Addendum 136 – UN Regulation No. 137

Revision 2 - Amendment 5

03 series of amendments – Date of entry into force: 15 June 2024

Uniform provisions concerning the approval of passenger cars in the event of a frontal collision with focus on the restraint system

Model A

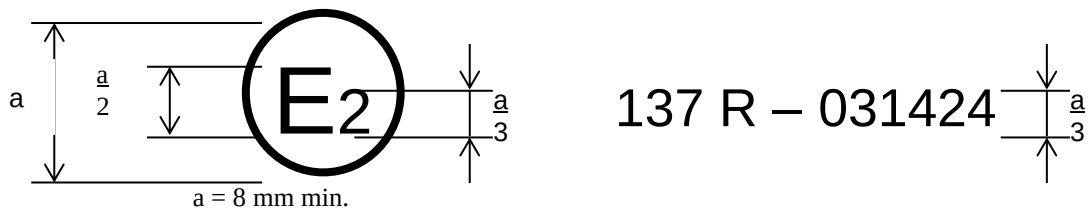
Annex 2, amend to read:

The above approval mark affixed to a vehicle shows that the vehicle type concerned has, with regard to the protection of the occupants in the event of a frontal collision, been approved in France (E 2) pursuant to Regulation No. 137 under approval number 011424. The approval number indicates that the approval was granted in accordance with the requirements of Regulation No. 137 03 series of amendments.

Model B

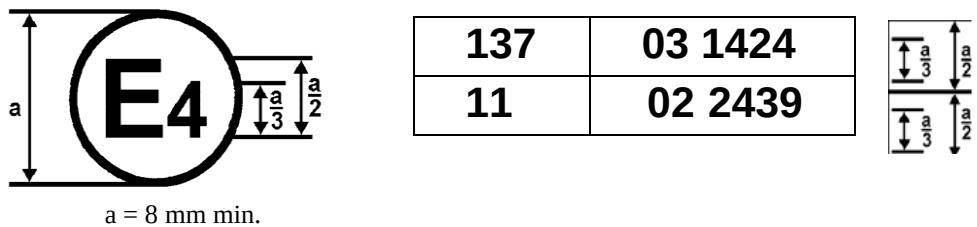
The above approval mark affixed to a vehicle shows that the vehicle type concerned has been approved in the Netherlands (E 4) pursuant to Regulations Nos. 137 and 11.¹ The first two digits of the approval numbers indicate that, at the dates when the respective approvals were granted, Regulation No. 137 incorporated the 03 series of amendments and Regulation No. 11 incorporated the 02 series of amendments.
